06 - 2011
5007FA / 5007FAK (MKC)
(Made in China)
7-1/4" CRCLR SAW W/LIGHT, BRAKE

SERVICE CHANGES

2. Changes on Motor Housing etc.

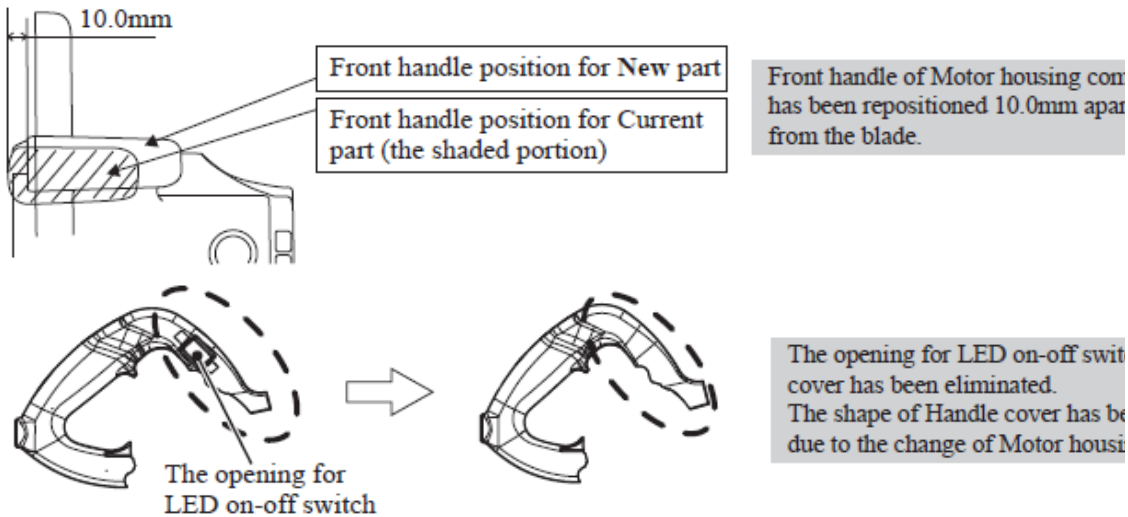
(TI#A2015)

| Item No. | Description | Type 1 | Type 2 |
| 012 | MOTOR HOUSING COMPLETE | 152989-9 | 142466-9 |
| 019 | HANDLE COVER | 417712-2 | 454973-3 |
| 066 | FRAME | 417468-7 | ----- |
| 067 | LIGHT CIRCUIT | 631453-8 | 631709-9 |
| 068 | SWITCH SLE6A | 651514-8 | ----- |
| 100 | RECEPTACLE | 654069-2 | ----- |

Above parts are completely interchangeable as a set.
